CUT PATTERN	
BACK FRAME NO.	
BASE FRAME NO.	
WOOD PATTERN

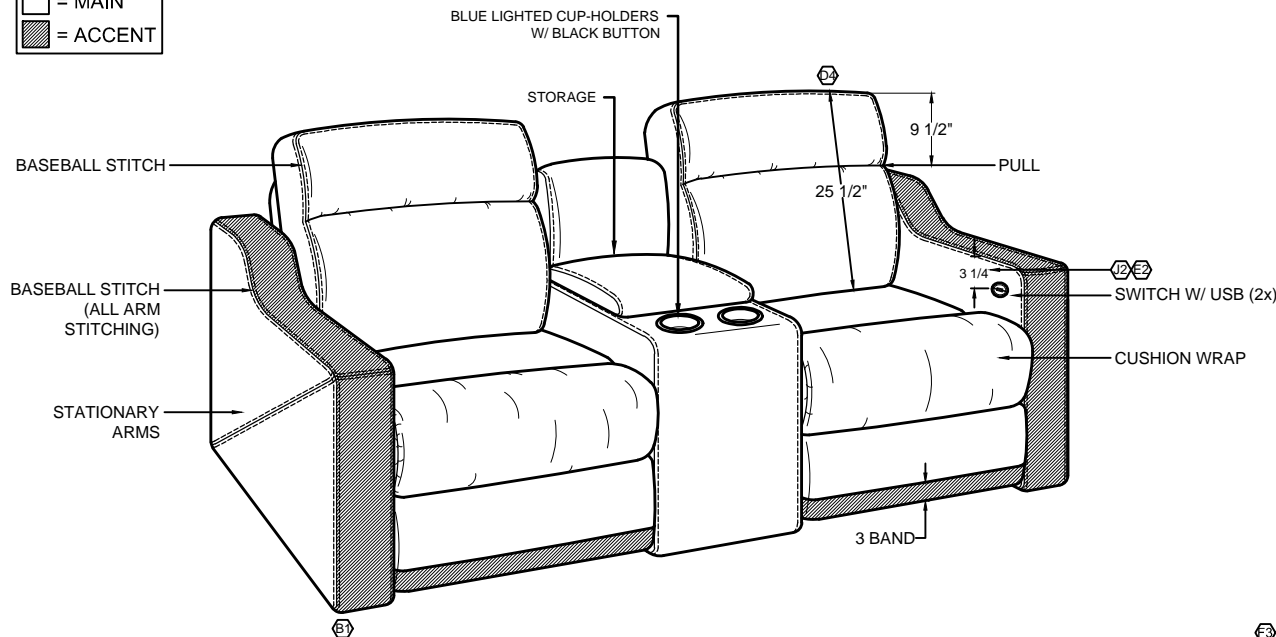
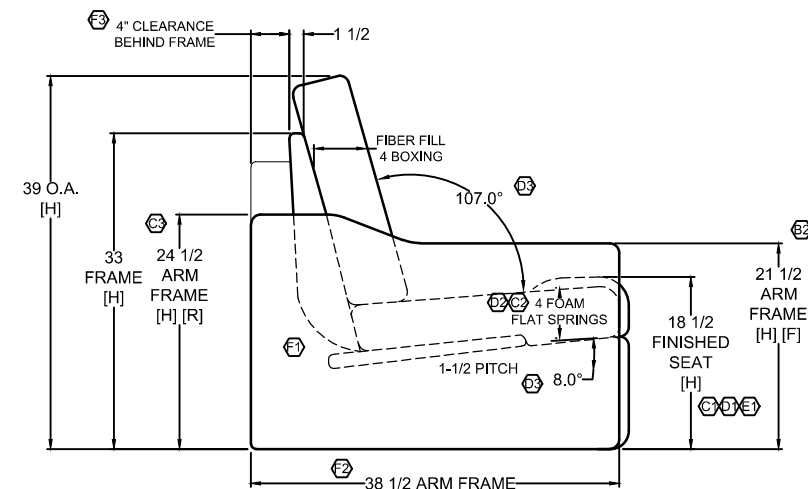
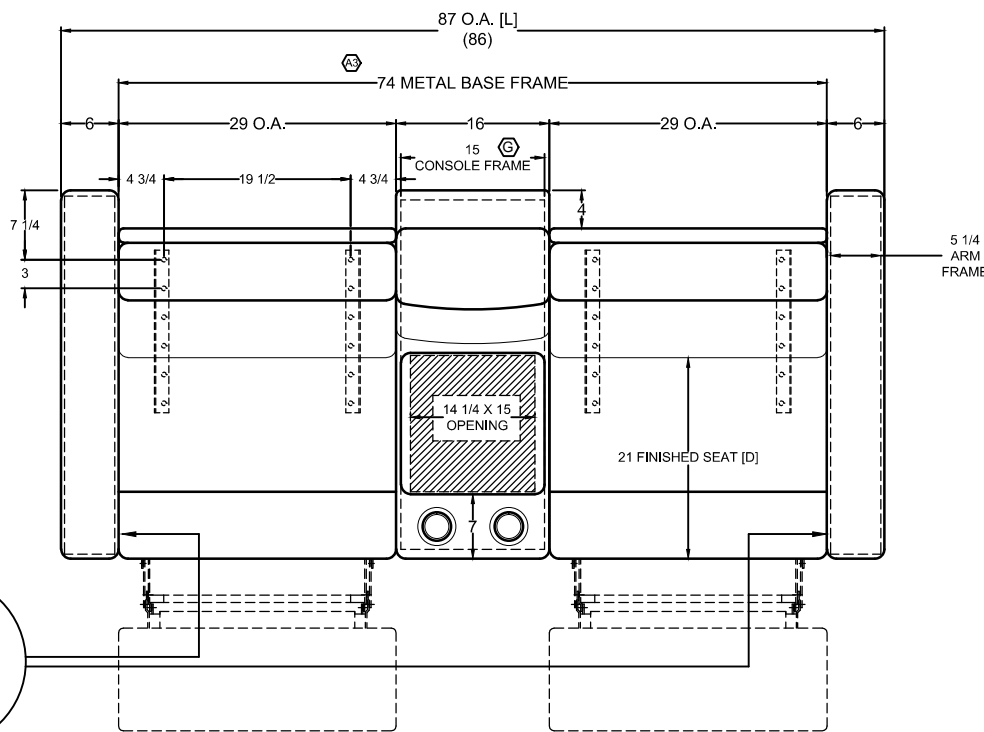
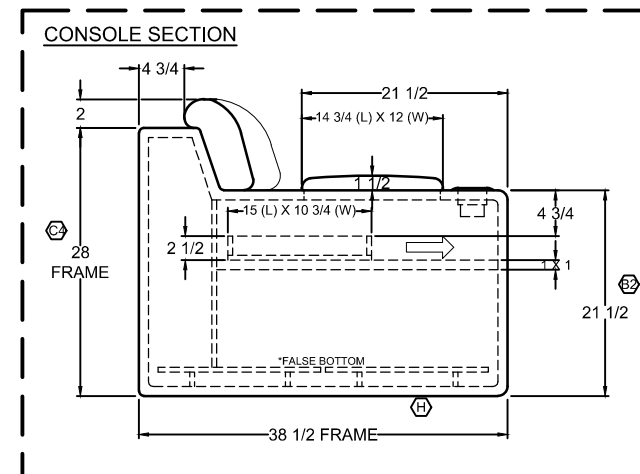
JA	J	[1] REMOVE BASEBALL STITCH FROM INSIDE OF ARMS. [2] CHANGE SWITCH PLACEMENT FROM TOP OF ARM TO 3-1/4"; WAS 5-1/4". (REF. ECO #089-2019)	08.08.19
JA	H	ADD FALSE BOTTOM TO MIDDLE CONSOLE. (REF. ECO #018-2019)	07.26.19
LB	G	PRODUCTION UPDATE: CHANGED THE WIDTH OF THE CONSOLE FRAME TO 15"; WAS 15 1/4".	04.25.19
JA	F	PRODUCTION UPDATE: [1] ADJUST BACK FRAME RENDERING ON SIDE VIEW. [2] REMOVED O.A. DEPTH AND ADDED 38-1/2" ARM FRAME DEPTH TO DRAWING. [3] ADJUSTED CLEARANCE ON SIDE VIEW. [4] ADDED 74" METAL BASE FRAME WIDTH TO DRAWING.	01.16.19
JA	E	PER RL, [1] CHANGE SEAT HEIGHT TO 18-1/2"; WAS 18". [2] ADD 5-1/4" HEIGHT DIMENSION FROM TOP OF ARM TO USB SWITCH.	11.27.18
JA	D	PER RL, [1] CHANGE SEAT HEIGHT TO 18"; WAS 18-1/2". [2] CHANGED SEAT FOAM TO 4"; WAS 5". [3] ADDED 8" ANGLE DIMENSION TO BOTTOM OF SEAT AND 107° ANGLE DIMENSION TO TOP OF SEAT AND BACK. [4] ADDED 25-1/2" HEIGHT DIMENSION TO BACK PILLOW.	11.21.18

JA	C	PRODUCTION UPDATE: [1] CHANGE SEAT HEIGHT TO 19-1/2"; WAS 18". [2] CHANGE SEAT CUSHION FOAM TO 5"; WAS 4". [3] CHANGED BACK ARM FRAME HEIGHT TO 24-1/2"; WAS 26-1/2". [4] CHANGED BACK CONSOLE FRAME HEIGHT TO 28"; WAS 30".	11.06.18
JA	B	PER RL, [1] ADD ACCENT TO FRONT OF ARM. [2] REDUCED ARM AND CONSOLE FRAME HEIGHT TO 21-1/2"; WAS 23-1/2".	11.02.18
JA	A	PER PRODUCTION, REMOVED ARM FRAME DIMENSION DESCRIPTION FROM DRAWING.	10.31.18
